SI B52 02 17
Seats

SERVICE ACTION: CHECK PUMP FOR BACKREST WIDTH ADJUSTMENT

This Service Information bulletin supersedes SI B52 02 17 **dated March 2017**

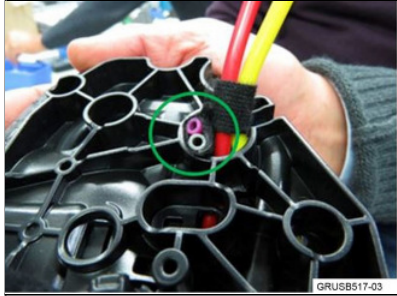
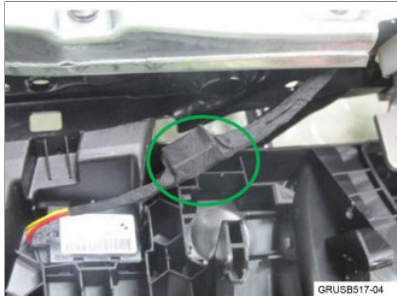
<p> Note on Competition Seat</p> <p>Both the lines are not required, the competition seat does not have lumbar support, when replacing the air pump. The unused lines have to be cut off using a suitable tool. Pay careful attention to the correct line colors when cutting off. Use the removed part as a reference; see image.</p>
	<p>Tie the unused connector for the lumbar support switch back as seen in image on left.</p>
